ONI-1: HISTORIC KENTON FIRE HOUSE

2209 N SCHOFIELD, PORTLAND OR
EXTERIOR

ONI-1: Historic Kenton Firehouse

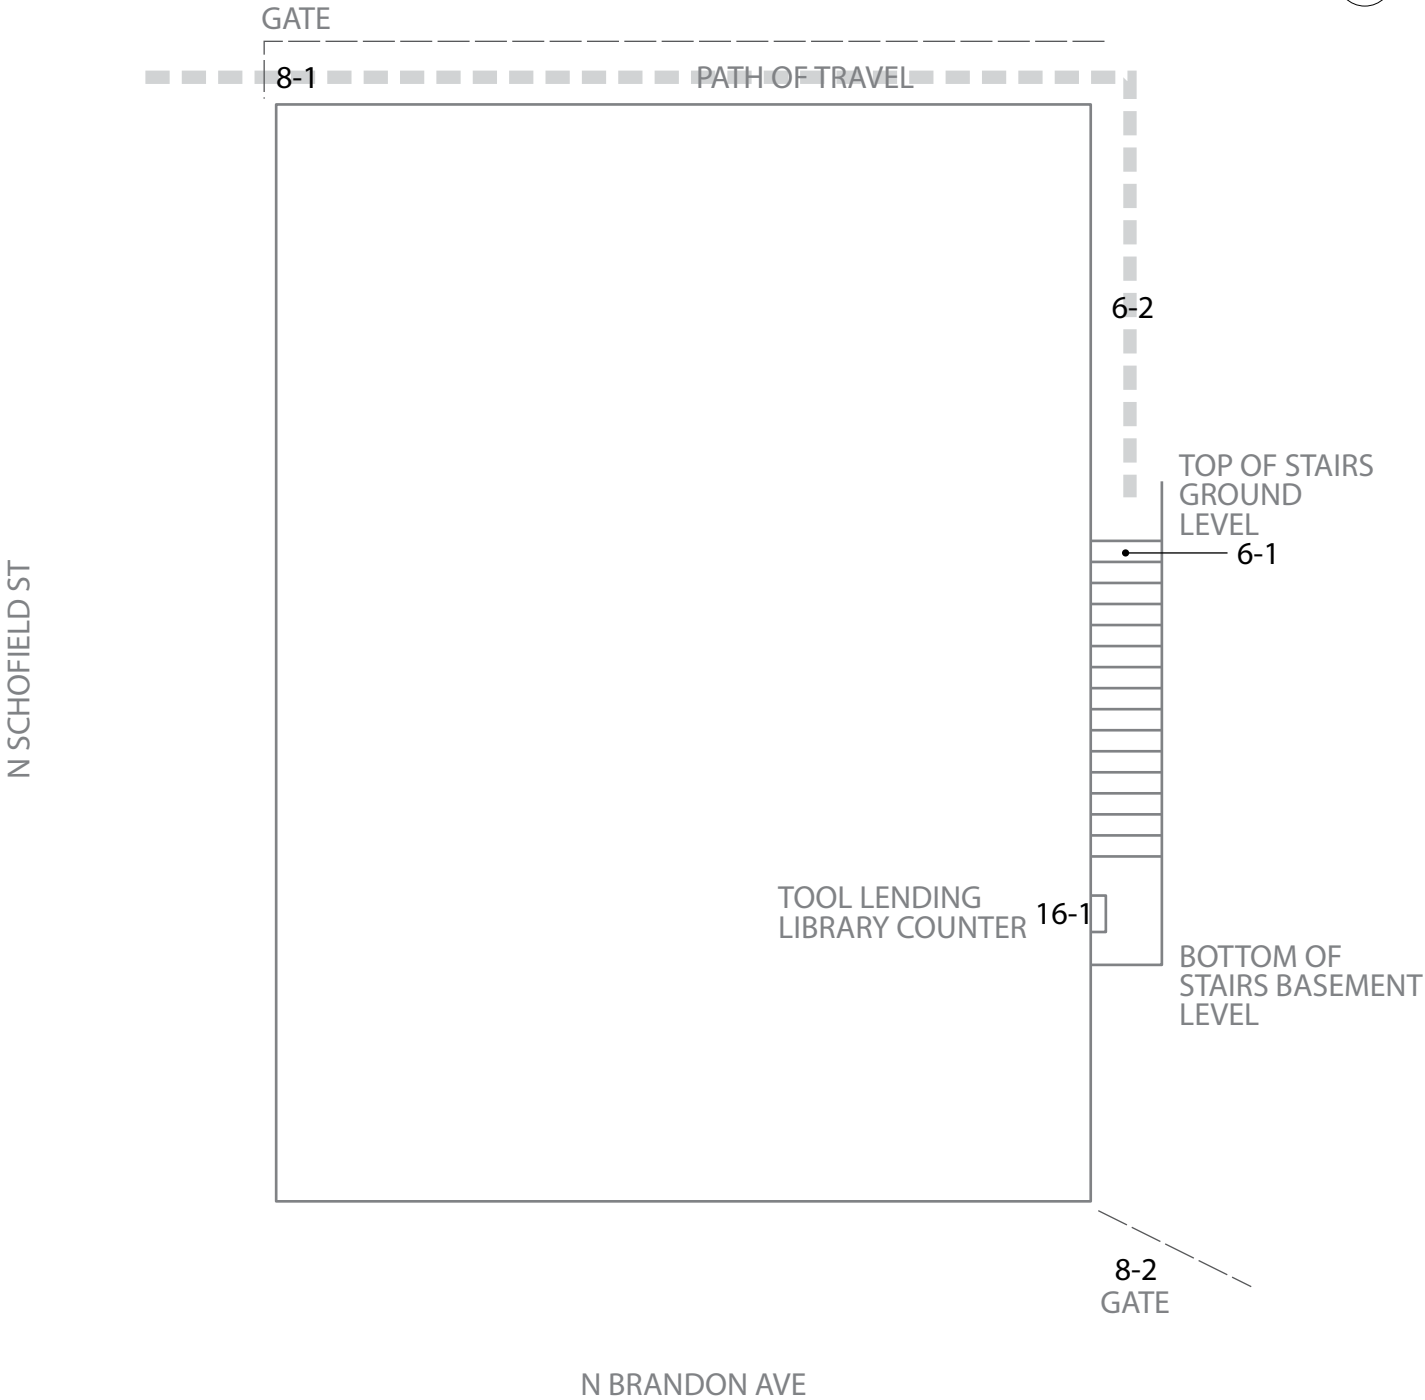
Exterior	
6 - 1	Stairway Category: 4
Install or modify handrails	\$3,680
Notes: There are no parallel extensions on the top of the stair run (12" min.). Handrails are mounted 1-3/4" from the wall (1-1/2" req.)	
State: ---	
Federal: 505.10.2, 505.5	
Replace stairs	\$4,800
Notes: Tread length is 10-1/2" (11" min.) There are 16 risers.	
State: ---	
Federal: 504.2	
EQUIVALENT FACILITATION CONSIDERATION	\$0
Notes: A call button will be installed at gate 8-2. This will allow a member of the public to receive assistance and access the Tool Lending Library program without having to use stair 6-1.	
State: -	
Federal: -	
6 - 2	Stairway Category: 4
Install or modify handrails	\$690
Notes: Handrails are not provided.	
State: ---	
Federal: 505.10.2, 505.4	
EQUIVALENT FACILITATION CONSIDERATION	\$0
Notes: Alternate entrances on the first floor are provided.	
State: -	
Federal: -

Exterior		
8 - 1	Door/Gate	Category: 4
Regrade surface		\$459
Notes: Clear space on the push side of the gate has slopes up to 7.5%. Clear space on the swing side of the gate has slopes up to 6.4% (2% max.)		
State: ---		
Federal: 404.2.4.4		
Provide or modify door kickplate		\$100
Notes: Kick plate is not provided on gate		
State: ---		
Federal: 404.2.10		
EQUIVALENT FACILITATION CONSIDERATION		\$0
Notes: This gate is not accessible. Directional signage on this gate will be installed to route the public to gate 8-2.		
State: -		
Federal: -		
8 - 2	Door/Gate	Category: 1
Regrade surface		\$459
Notes: Clear space on the push side of the gate has slopes up to 9.4% (2% max.)		
State: ---		
Federal: 404.2.4.4		
Provide or modify door kickplate		\$100
Notes: Kick plate is not provided on gate		
State: ---		
Federal: 404.2.10		
16 - 1	Built-in Elements	Category: 2
Provide an accessible path of travel		\$0
Notes: Accessible path of travel to the Tool Lending Library service counter is not provided due to stairs. Equivalent facilitation will be provided by providing a call button at gate 8-2.

State: ---		
Federal: 206.2		
Provide an accessible counter		\$2,500
Notes: Counter is located 41" above the ground surface (36" max.)		
State: ---		
Federal: 227.3, 403

ONI-1: HISTORIC KENTON FIRE HOUSE
2209 N SCHOFIELD, PORTLAND OR
1ST FLOOR

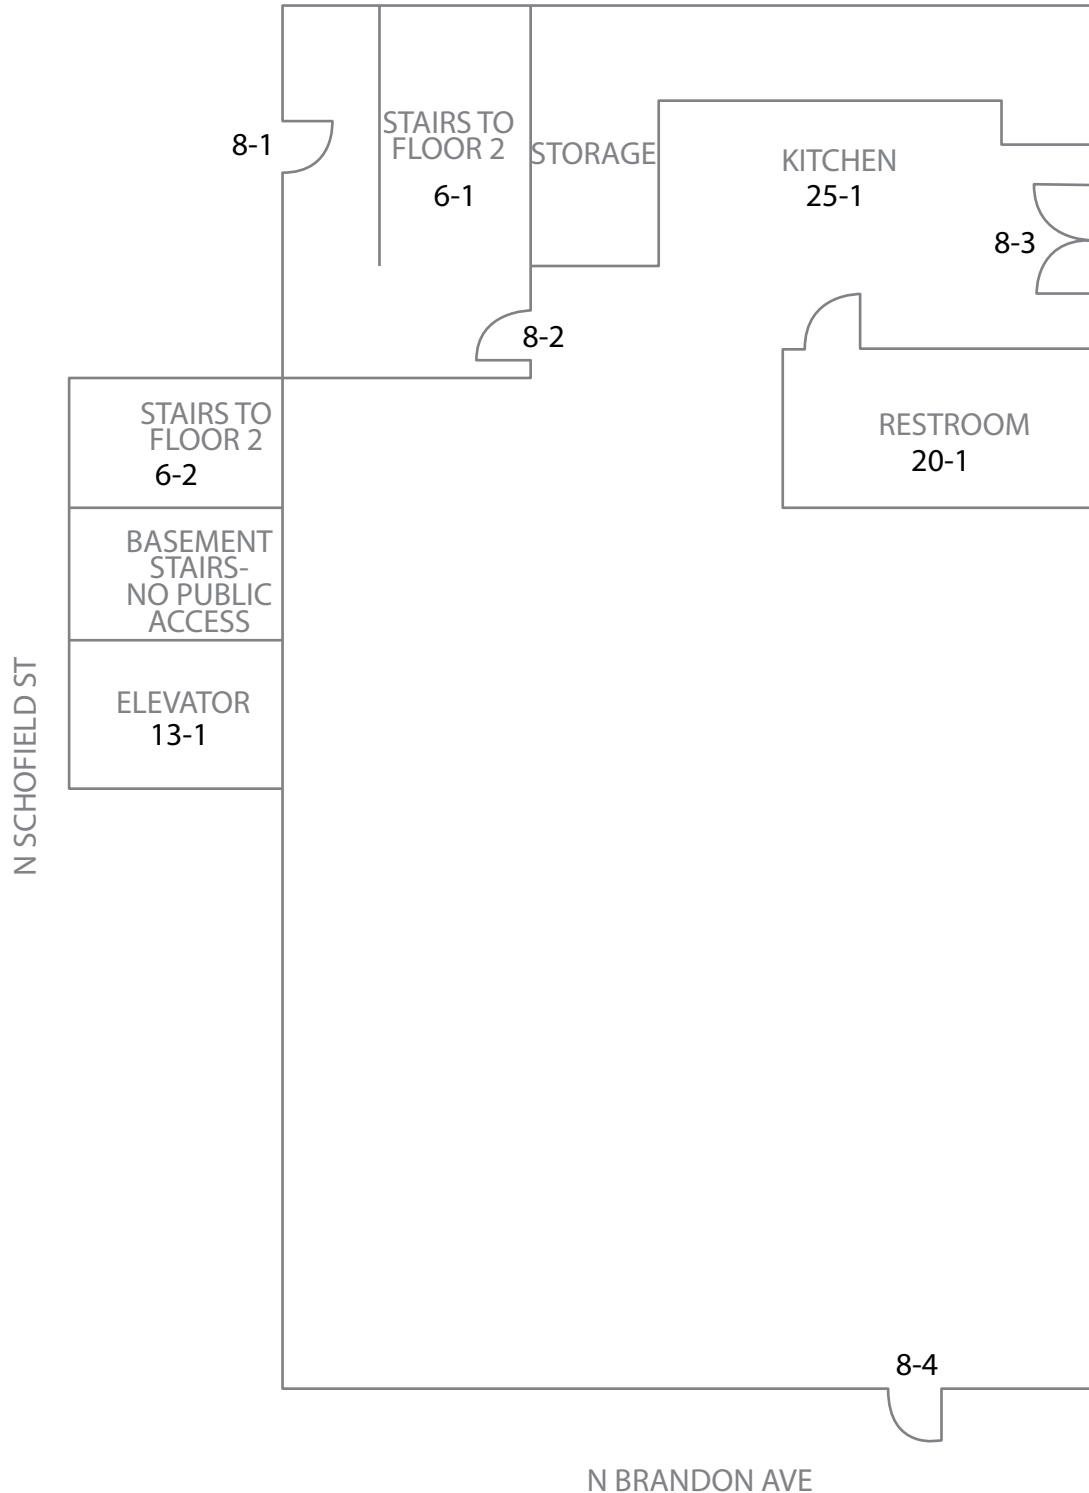
Floor 1		
6 - 1	Stairway	Category: 4
Replace stairs		\$7,200
Notes: Stair has 24 risers. Stair width varies between 34 to 35-3/4" (36" min.) Tread length is 10-1/2" (11" min.)		
State: ---		
Federal: 1009.1, 504.2		
Install or modify handrails		\$5,520
Notes: Handrails are located on one side of the stair run. Top extension is not provided Top surface of the handrail is mounted 33" (34-38" req.) Handrails are located 2" from the wall (1-1/2" req.) Ends of handrails do not return to floor, wall or post.		
State: ---		
Federal: 505.10.2, 505.4		
EQUIVALENT FACILITATION CONSIDERATION		\$0
Notes: Stair access is not required. Second floor is for staff only.		
State: -		
Federal: -		
6 - 2	Stairway	Category: 4
Replace stairs		\$6,300
Notes: Stair has 21 risers. Stair width is 34 -3/4" (44" min.) Tread length is 10-1/2" (11" min.) Risers are 8-1/2" (4-7" req.)		
State: ---		
Federal: 1009.1, 504.2		
Install or modify handrails		\$4,830

Notes: Handrails are not provided. There are 21 risers.		
State: ---		
Federal: 505.10.2, 505.4		
Repair stair nosings		\$420
Notes: Stair nosing projects 1-3/4" (1-1/2" max.)		
State: ---		
Federal: 504.5		
EQUIVALENT FACILITATION CONSIDERATION		\$0
Notes: Stair access is not required. Second floor is for staff only.		
State: -		
Federal: -

Floor 1		
8 - 1	Door/Gate	Category: 1
Provide sign(s) indicating accessible entries and facilities		\$250
Notes: Keypad is required for entry. International Symbol of Accessibility is not provided on the primary entrance.		
State: ---		
Federal: 216.6		
Modify door window or side light		\$500
Notes: Window in door is located 50-1/4" AFF (43" max.)		
State: ---		
Federal: 404.2.11		
Increase or provide maneuvering or clear floor area		\$175
Notes: Maneuvering clearance on pull-side of the door (front approach) is 40" (60" min.).		
State: ---		
Federal: 404.2.4.1		
Provide two-way communication		\$1,000
Notes: Two-way communication system is provided to gain admittance. The system does not provide both a visual and audible signal.		
State: ---		
Federal: 708		
Provide an accessible path of travel		\$0
Notes: Two doors provide entry (8-1, 8-4) and neither is fully accessible. At least 60% of all public entries are required to be accessible.

State: -		
Federal: 206.4.1		
Regrade surface		\$255
Notes: Pull-side of the door slope is 4.4% (2% req.).		
State: ---		
Federal: 404.2.4.4		
EQUIVALENT FACILITATION CONSIDERATION		\$0
Notes: Directional signage will be installed to route the public to use door 8-4. Door 8-4 will be the designated accessible entrance.		
State: -		
Federal: -

Floor 1		
8 - 2	Door/Gate	Category: 2
Provide additional strike edge clearance		\$3,000
Notes: Strike edge clearance on the pull side of the door is not provided (18" min.) due to banister.		
State: ---		
Federal: 404.2.4.1		
8 - 3	Door/Gate	Category: 4
Provide an accessible path of travel		\$0
Notes: Accessible path of travel is not provided due to stairs. Alternate entrances on the first floor are provided.		
State: ---		
Federal: 206.2.4, 404.1		
8 - 4	Door/Gate	Category: 1
Provide sign(s) indicating accessible entries and facilities		\$250
Notes: Signage indicating the location of the accessible entrance is not provided.		
State: ---		
Federal: 216.6		
Replace or adjust door hardware		\$1,000
Notes: Door hardware is a knob that requires grasping and twisting.		
State: ---		
Federal: 309.4		
Enlarge door opening		\$1,650
Notes: Height of clear opening is 78" (80" min.)		
State: ---		
Federal: 404.2.3.2

Floor 1	
13 - 1 Elevator	Category: 4
Enlarge elevator	\$150,000
Notes: Elevator and associated doors are not accessible. Clear width of elevator car door is 25-3/4" (36" min.)	
State: ---	
Federal: 407.4.1	
Adjust elevator operation	\$0
Notes: Cage gates are prohibited.	
State: ---	
Federal: 407.3.1	
Adjust elevator controls and labeling	\$0
Notes: Car controls are not accessible.	
State: ---	
Federal: 308.2.1, 308.3.1, 407.2.1.1, 407.2.1.2, 407.2.1.4, 407.2.1.5	
EQUIVALENT FACILITATION CONSIDERATION	\$0
Notes: Elevator access is not required. Second floor is for staff only.	
State: -	
Federal: -

Floor 1	
20 - 1	Single User Restroom Category: 2
Install sign	\$250
Notes: Restroom sign is centered 67" AFF (60" req.) Sign does not have International Symbol of Accessibility.	
State: ---	
Federal: 703, 703.4.1, 703.4.2	
Increase or provide maneuvering or clear floor area	\$175
Notes: Turning space in restroom is 47-1/2" (60" min.).	
State: ---	
Federal: 304.3.1, 306.3, 603.3.2.1	
Replace or reposition fixtures	\$1,500
Notes: Centerline of the water closet is 19" (16-18" req.)	
State: ---	
Federal: 604.9, 604.9.1	
Replace or modify grab bars	\$250
Notes: Side grab bar is 36" (42" min.). Total length of side grab bar from the back wall is 44-1/2" (54" min.)	
State: ---	
Federal: 609.5.1	
Modify lavatory or counter clearances	\$0
Notes: Knee space and toe clearance are not provided under the lavatory counter due to storage items.	
State: ---	
Federal: 306.2, 306.2.3, 306.3, 306.3.3

Floor 1	
25 - 1	Kitchen
Category: 2	
Increase or provide maneuvering or clear floor area	\$175
Notes: Floor area near entrance to the kitchen has a slope of 4% (2% max.) Approx. 10 ft.	
State: ---	
Federal: 305.3, 305.5	
Modify operating mechanism	\$250
Notes: Controls are located on the back wall.	
State: ---	
Federal: 309	
Modify lavatory or counter clearances	\$2,500
Notes: Kitchen work surface and sink counter is located 35-1/2" AFF (34" max.) Knee and toe clearance are not provided.	
State: ---	
Federal: 306.2.3, 306.3.3, 804.3.2	
Replace or reposition dispensers or mirrors	\$150
Notes: Paper towel dispenser is mounted 51" AFF (48" max.)	
State: ---	
Federal: 308

ONI-1: HISTORIC KENTON FIRE HOUSE
2209 N SCHOFIELD, PORTLAND OR
2ND FLOOR

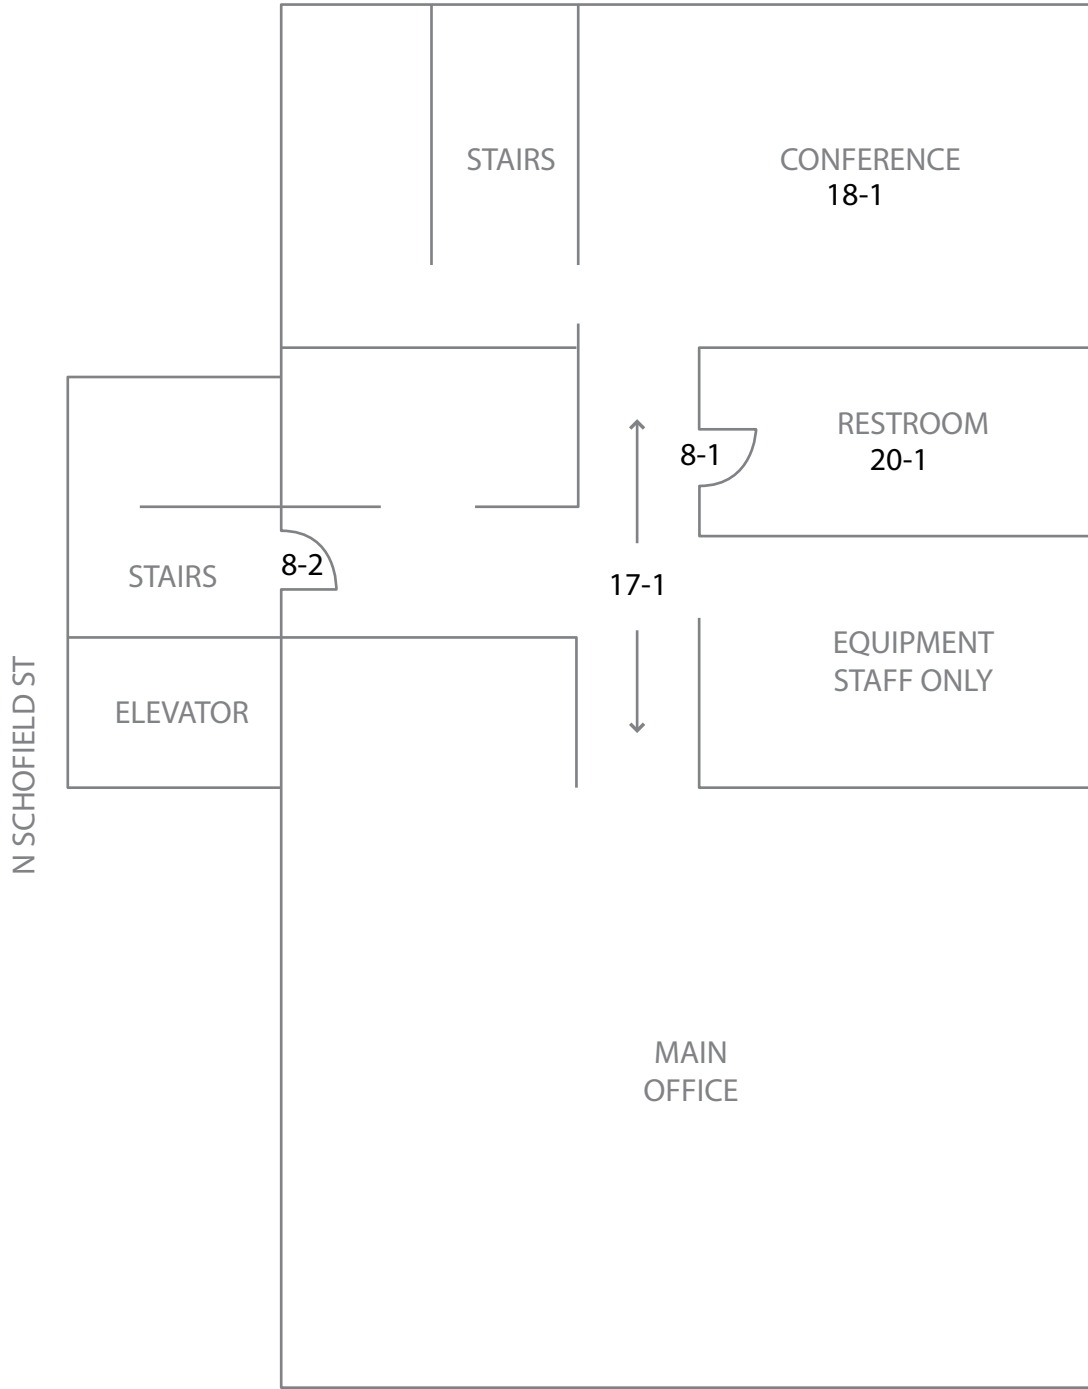
Floor 2		
8 - 1	Door/Gate	Category: 4
Enlarge door opening		\$1,650
Notes: Width of clear opening is 27-3/4" (32" min.)		
State: ---		
Federal: 404.2.3		
Increase or provide maneuvering or clear floor area		\$175
Notes: Strike edge clearance on the push side of the door is 40-3/4" (48" min.)		
State: ---		
Federal: 404.2.4.1		
EQUIVALENT FACILITATION CONSIDERATION		\$0
Notes: Second floor is for staff only.		
State: -		
Federal: -		
8 - 2	Door/Gate	Category: 4
Install or modify permanent room signs		\$125
Notes: Tactile and Braille EXIT sign is not provided.		
State: ---		
Federal: 703.4.1		
Modify door window or side light		\$500
Notes: Window in door is located 44" AFF (43" max.)		
State: ---		
Federal: 404.2.11		
EQUIVALENT FACILITATION CONSIDERATION		\$0
Notes: Second floor is for staff only.		
State: -		
Federal: -		
17 - 1	Corridor / Aisle	Category: 4
Reposition controls and outlets		\$2,000
Notes: Light switches are mounted 49" AFF and 49-1/2" AFF (48" max.).

State: ---		
Federal: 309.4		
EQUIVALENT FACILITATION CONSIDERATION		\$0
Notes: Second floor is for staff only.		
State: -		
Federal: -

Floor 2		
18 - 1	Room	Category: 4
	Reposition controls and outlets	\$2,000
Notes: Three electrical outlets are located 5" AFF (15-48" req.)		
State: ---		
Federal: 308.2.1		
	EQUIVALENT FACILITATION CONSIDERATION	\$0
Notes: Second floor is for staff only.		
State: -		
Federal: -		
20 - 1	Single User Restroom	Category: 4
	Renovate restroom	\$75,000
Notes: This restroom is not accessible and would require a complete renovation. Restroom is located on the second floor and is accessible only by stairs or a non-compliant elevator. The designated accessible restroom is located on the first floor.		
State: ---		
Federal: 604.8.1.2		
	Install sign	\$250
Notes: No sign directing people to the accessible room is provided.		
State: ---		
Federal: 216.8, 703.7.2.1		
	EQUIVALENT FACILITATION CONSIDERATION	\$0
Notes: Second floor is for staff only.		
State: -		
Federal: -
